## Addendum #2

RE: REQUEST FOR TENDER #2024-137-P01947  
Hess Street Elementary School – Renovation Project

April 30, 2024

**PROJECT TITLE**  
PARTIAL GROUND FLOOR PLANS - GENERAL - DEMOLITION & NEW

**SHEET NO.**  
A101

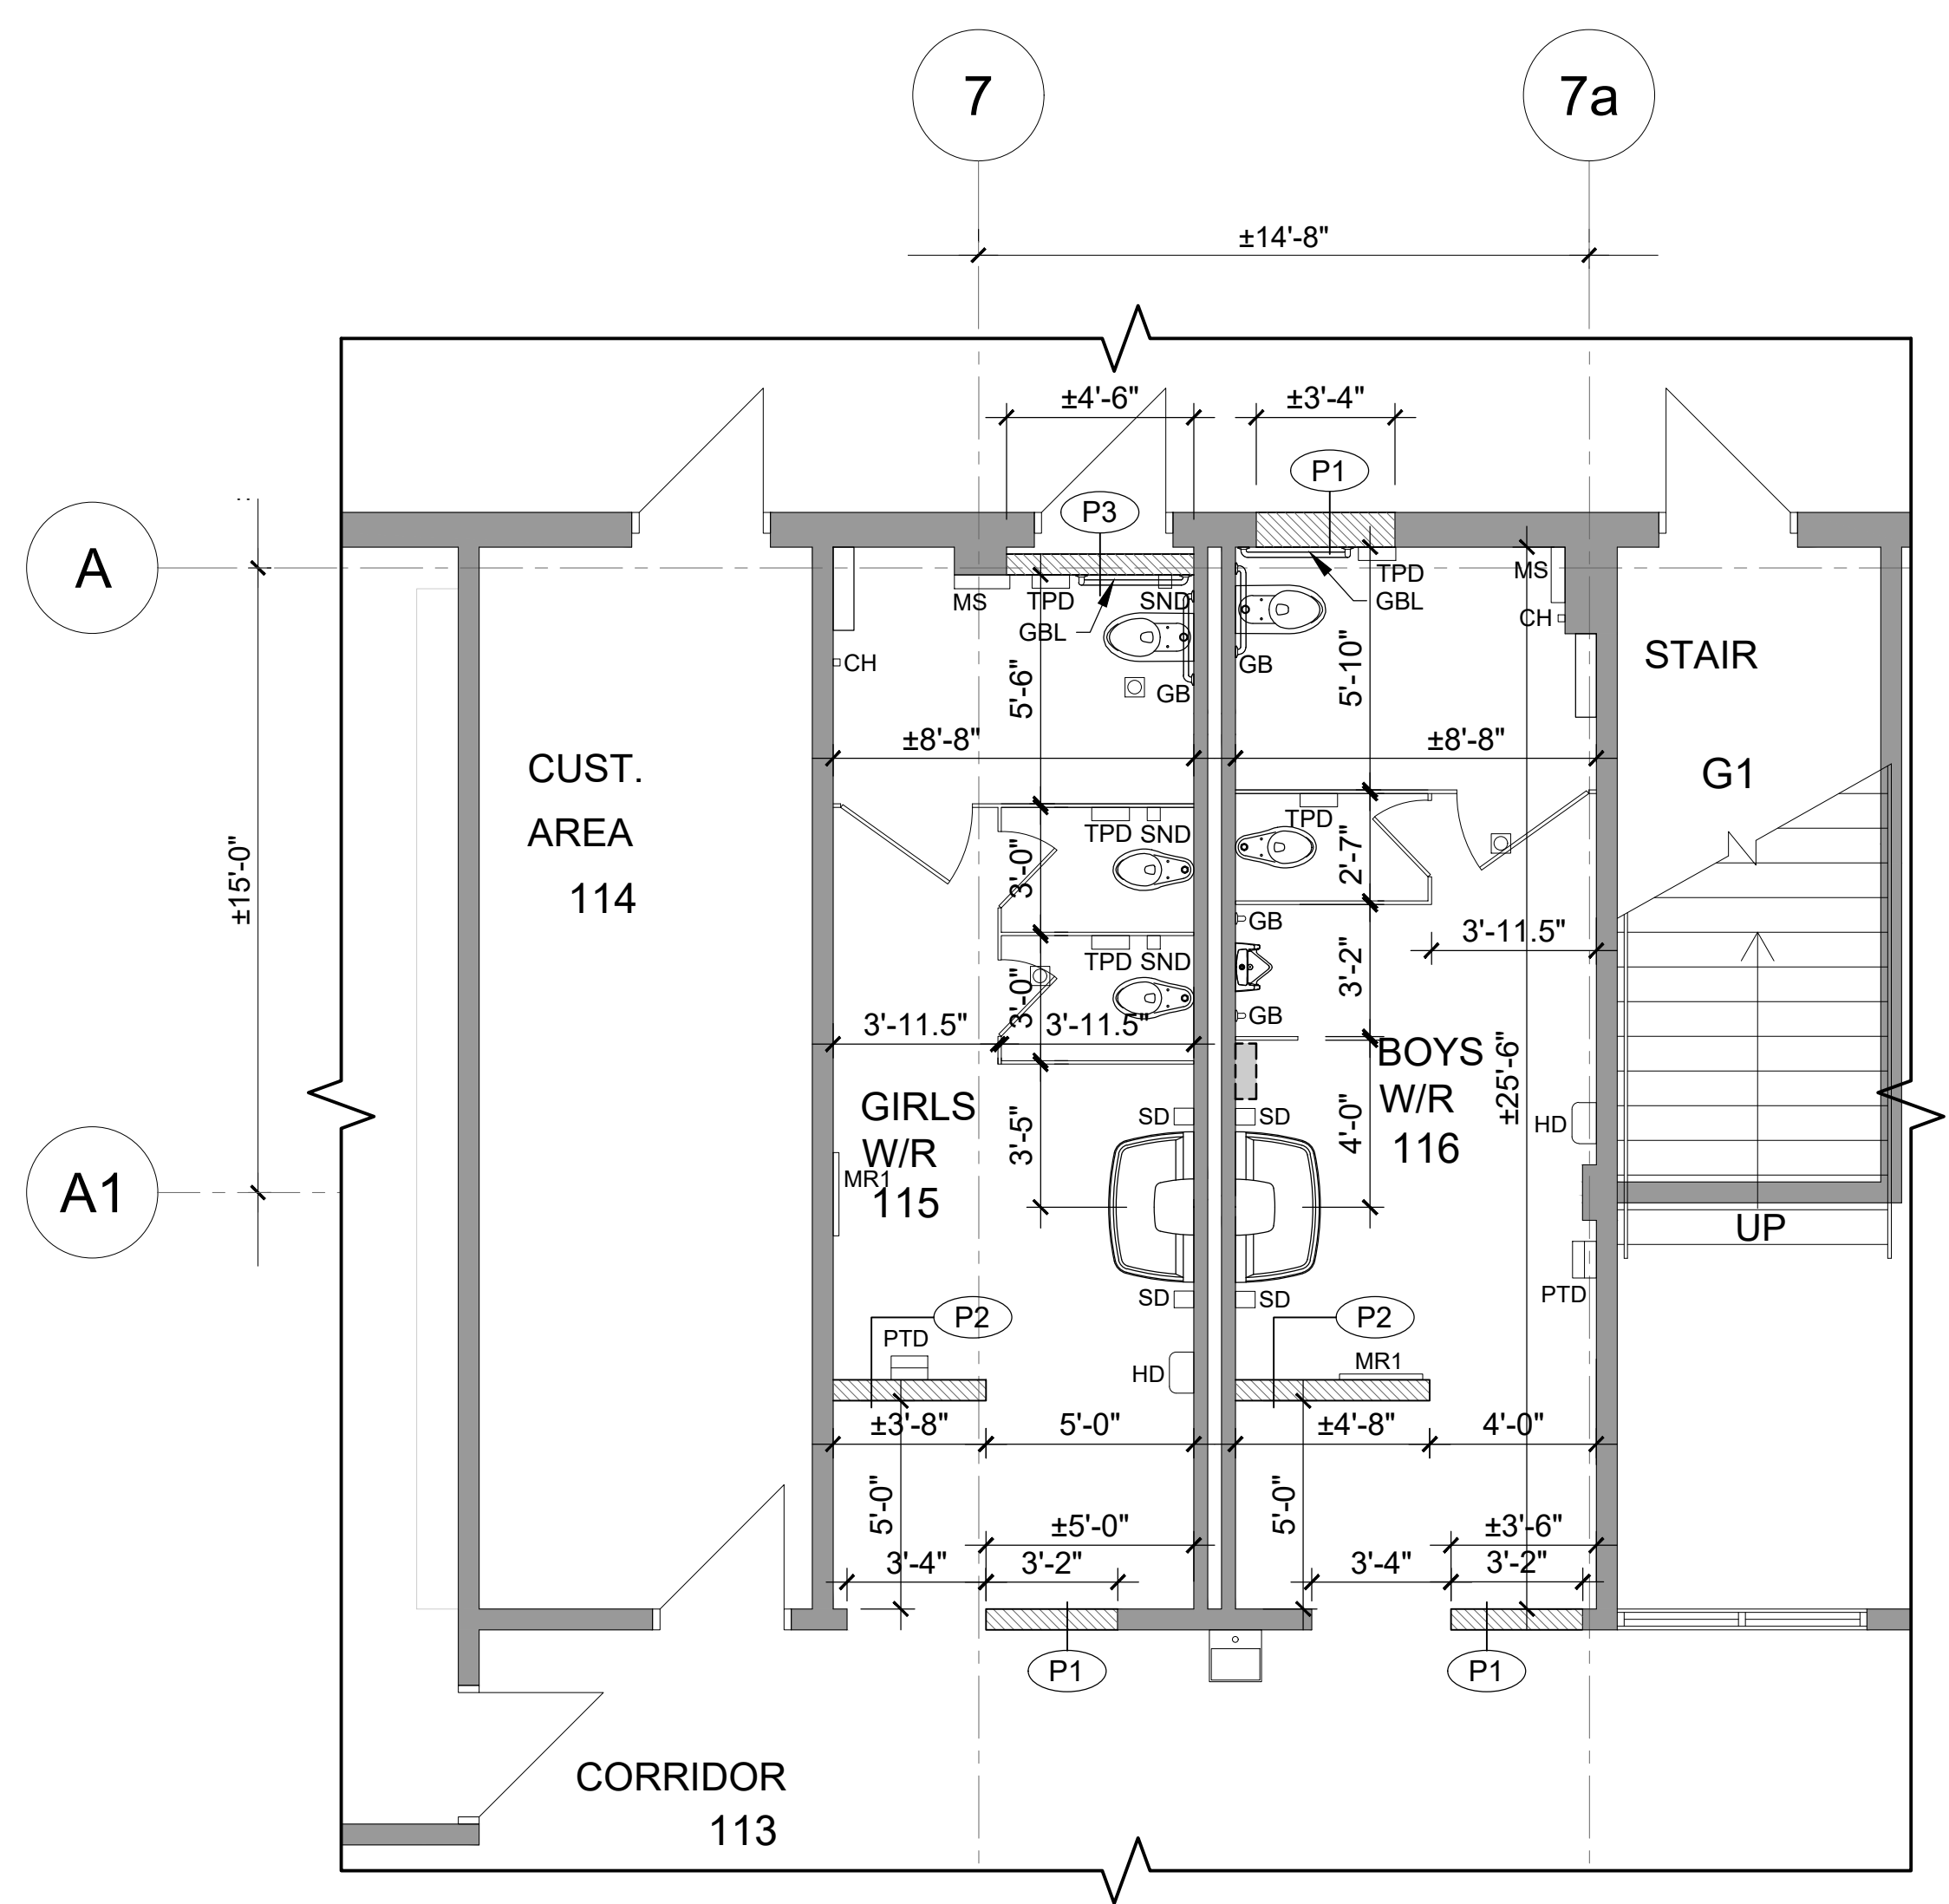
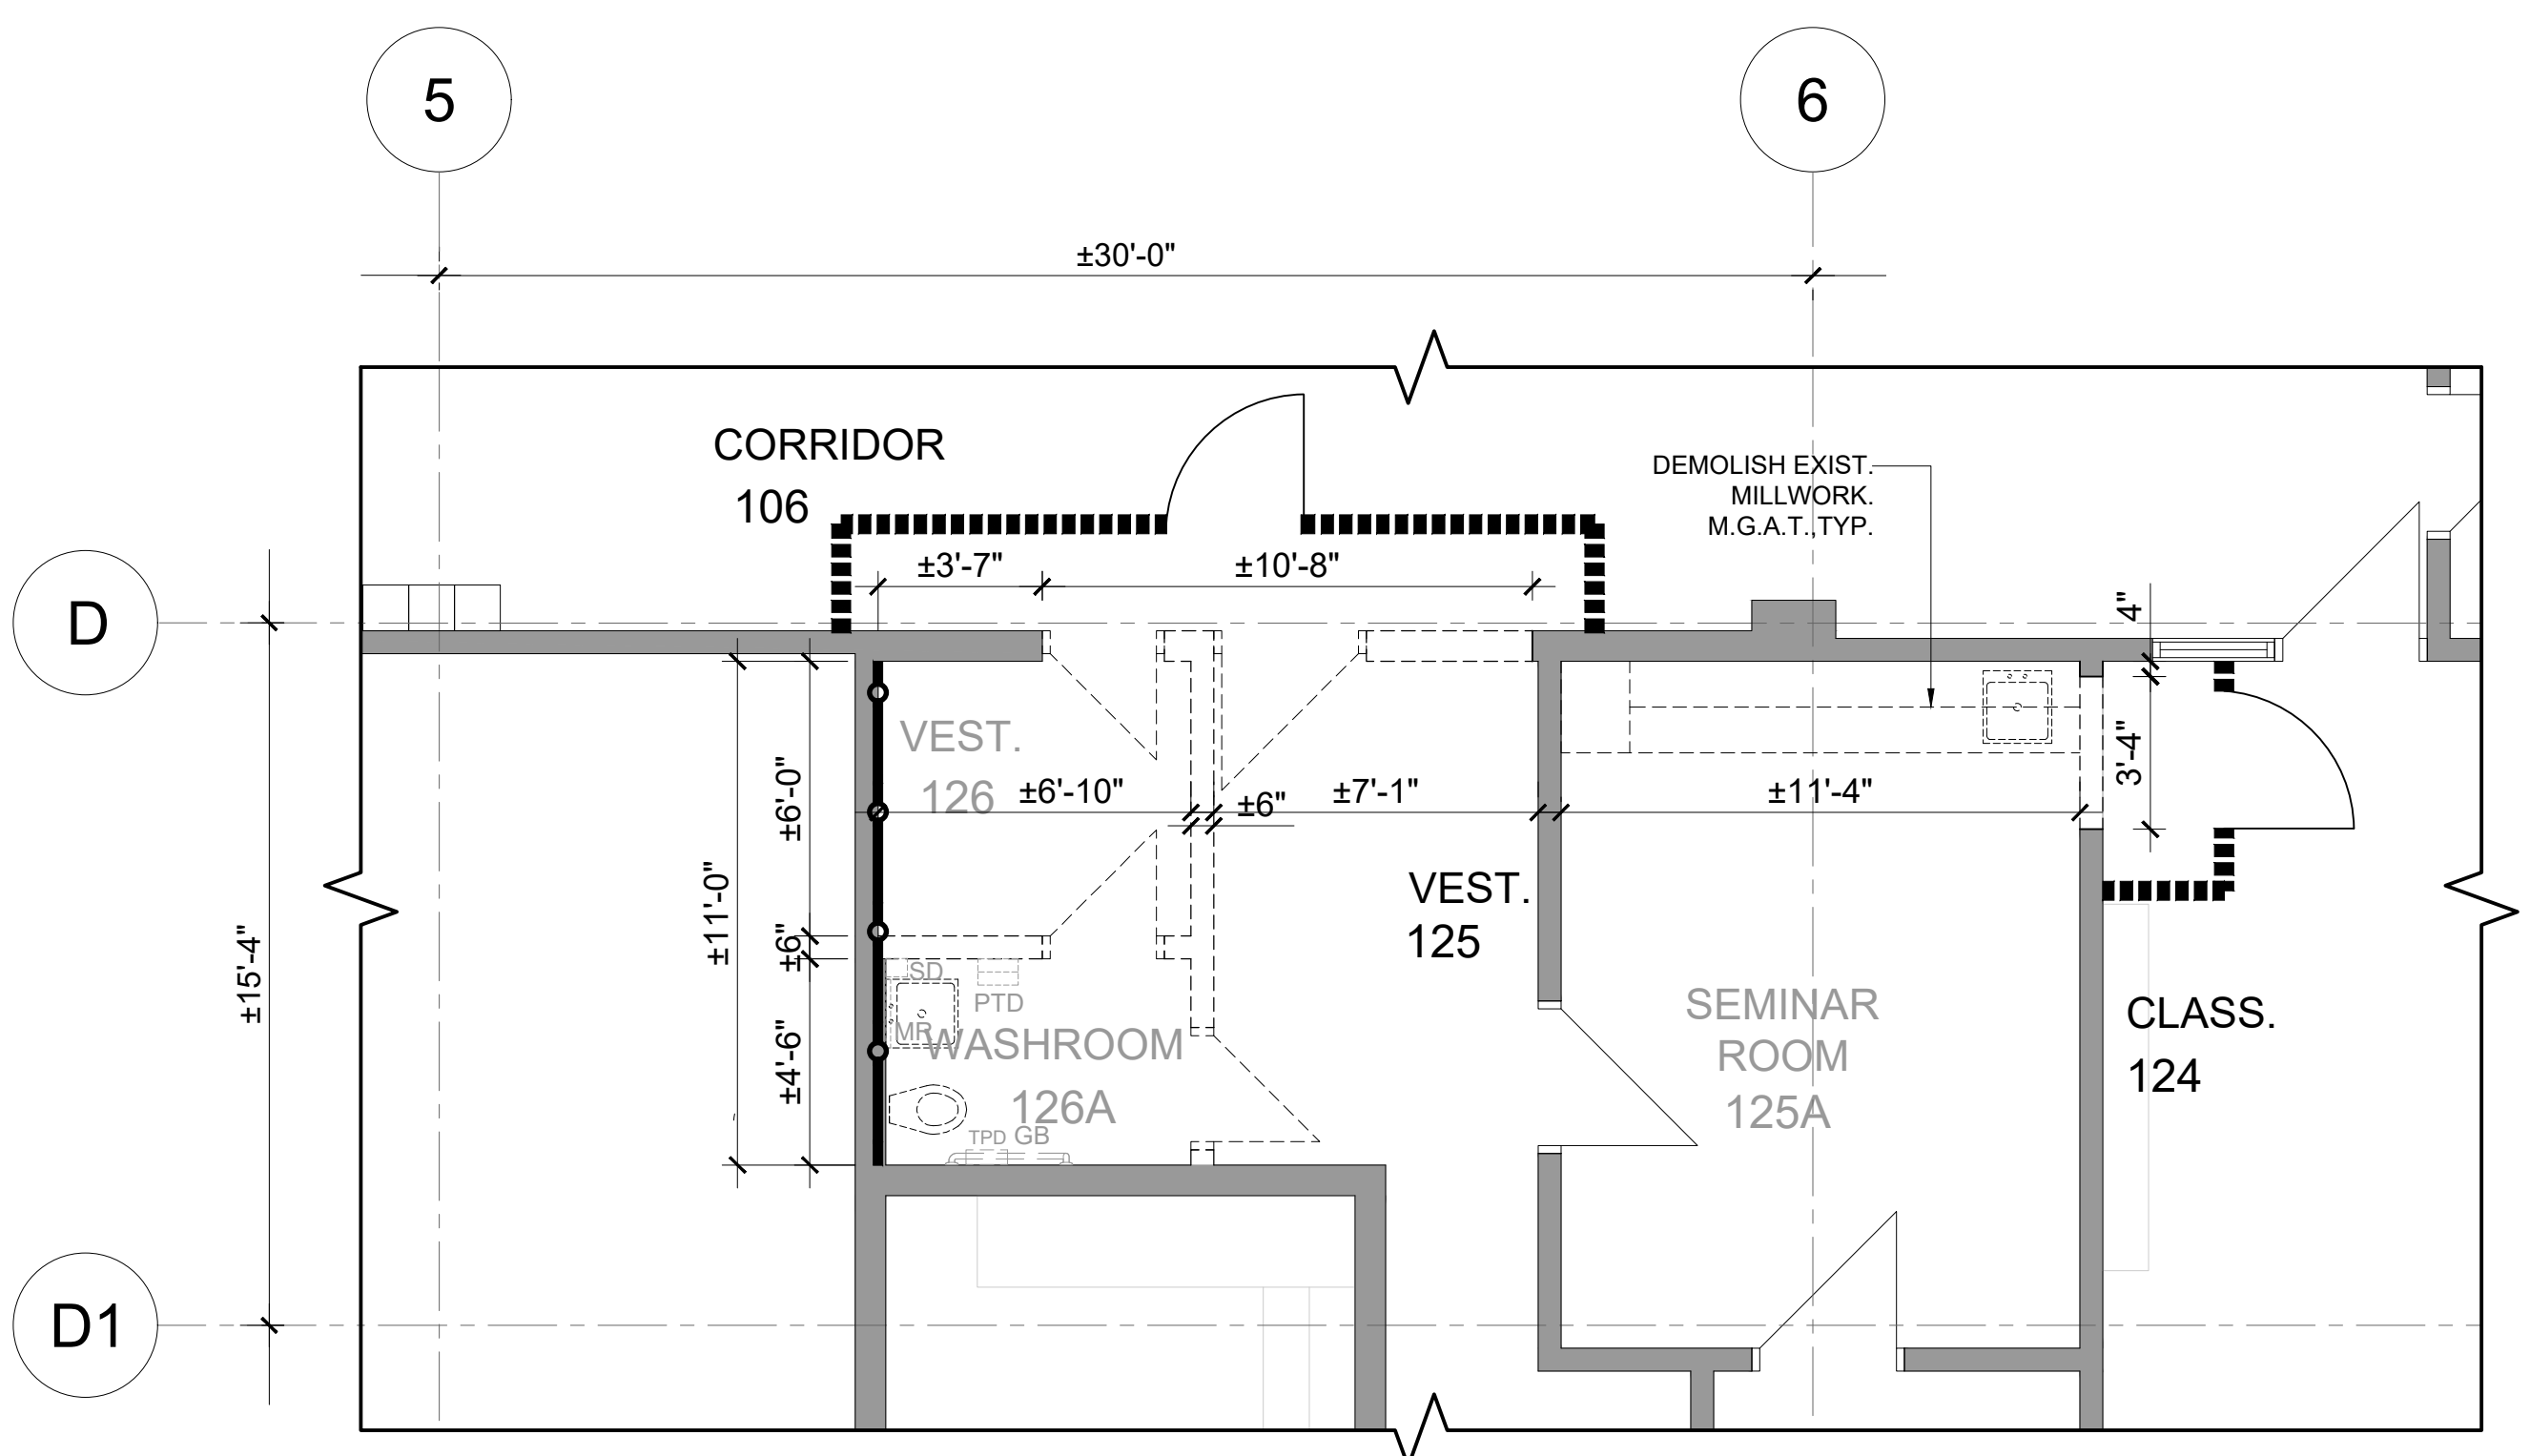
- 1) **Clarification:** In Gymnasium #105 all existing conduits to also be painted like the walls.
- 2) **Clarification:** Since the work is being performed during summer while the school is closed, new 1 hour rated construction hoarding partition (as shown on drawings A101 and A102) may be replaced with new Poly Tarps protection sheets.
- 3) **Clarification:** Refer to clarifications regarding Partition Types P1 and P2 in the attached Architectural drawings A101 and A102, dated April 30, 2024.
- 4) **Question:** On behalf of Gerflor Canada we request Rec6.2mm replace Multi-Use 6.2 to Section 096566 Resilient Athletic Surfacing Item #2.1.1 as the true equivalent to MultiFlex. Thank you.
